8.0 COMMENTS and RESPONSES

This section includes comments received during the circulation of the Draft Environmental Impact Report (EIR) for the Zone 2 Landslide Moratorium Ordinance Revisions; responses to the comments on the Draft EIR; and corrections and information added to the Final EIR, where appropriate, in response to comments related to the proposed project's environmental effects. Corrections or additional text discussed in the responses to comments are also shown in the text of the Final EIR in ~~strike through~~ (for deleted text) and underline (for added text) format. (Other minor clarifications and corrections to typographical errors are also shown as corrected in this format, including corrections not based on responses to comments. These changes do not introduce new information or otherwise affect the analysis or conclusions of the EIR).

Subject: Zone 2 Landslide Moratorium Ordinance Revisions (Planning Case No. ZON2009-00409)
SCH#: 2010121073

#1 OUR HOME ENTRANCE TO COMMUNITY

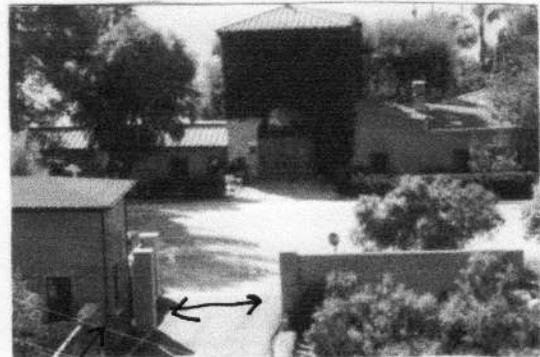
DAILY DIESEL EXHAUST DUMPED OVER OUR WALL DIRECTLY INTO OUR WINDOW AND KITCHEN DOOR.

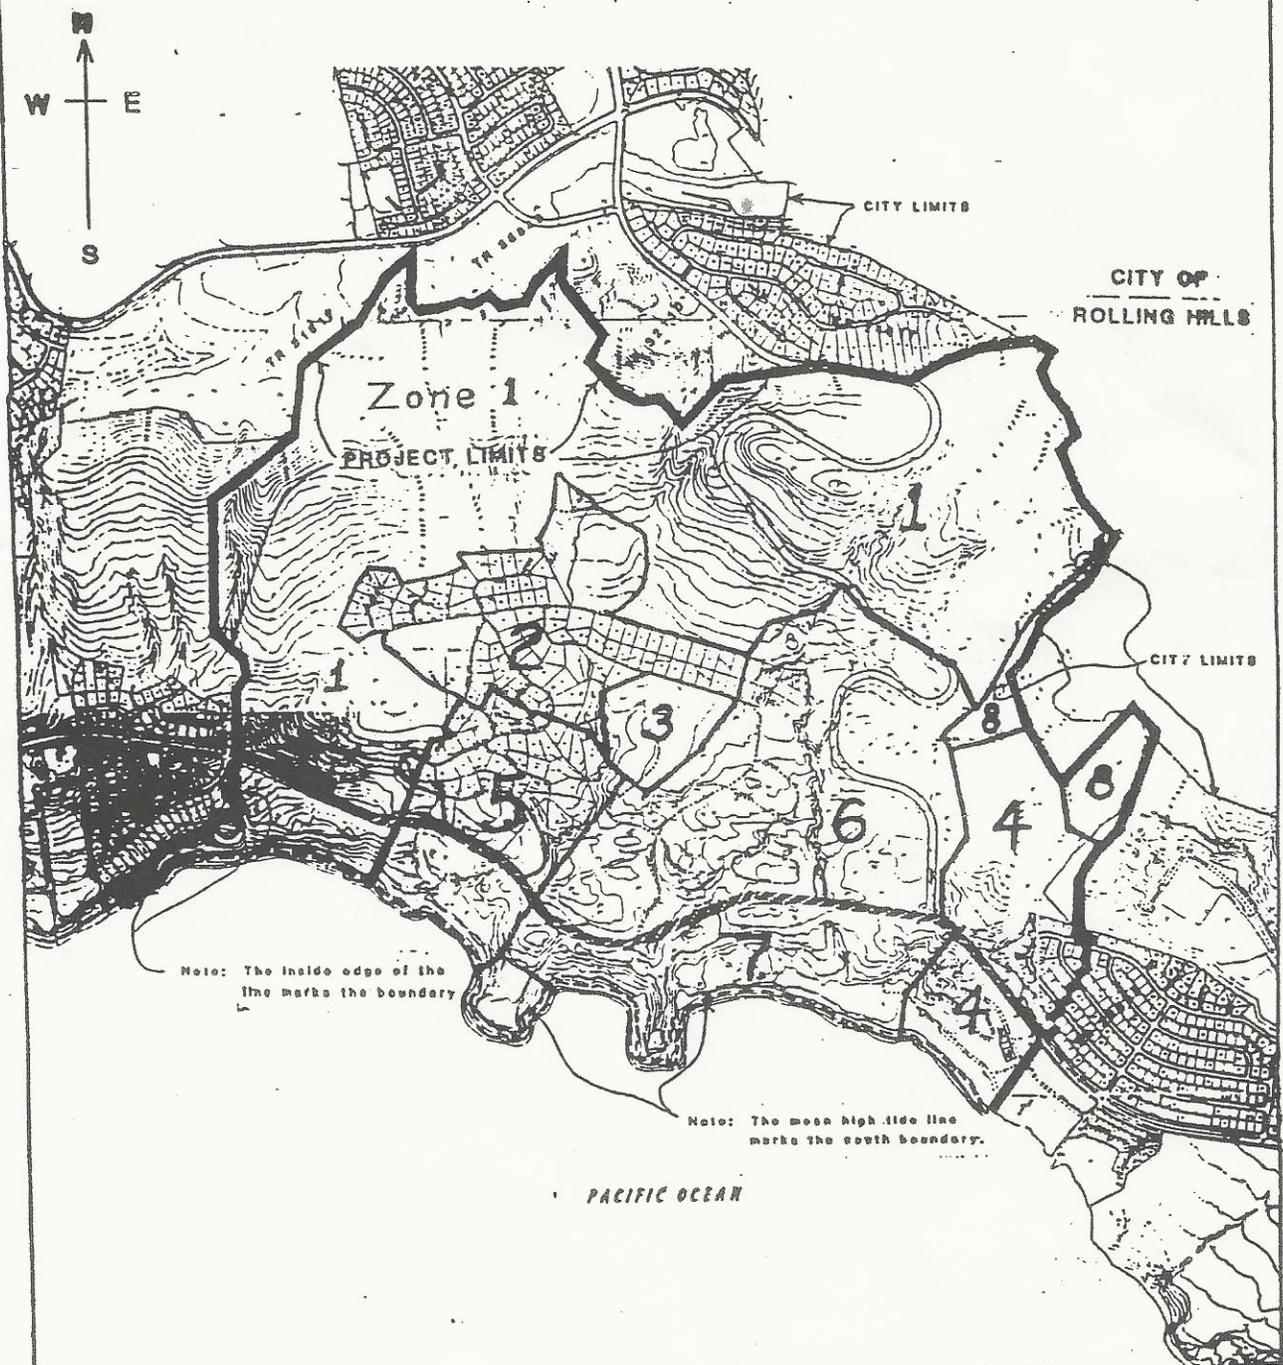
All "Monk" lots that have active building permits in process should be updated to D - Developed on this list.

APN - 7572-009-024 / 7 Plumtree - 2 of the potential lots are in Zone 1 on Dr. Elig's Zone Map. Zone 1 should not be on this list.

** 20 Vanderlip has submitted a lot split request to the City for 4 lots, not 6.
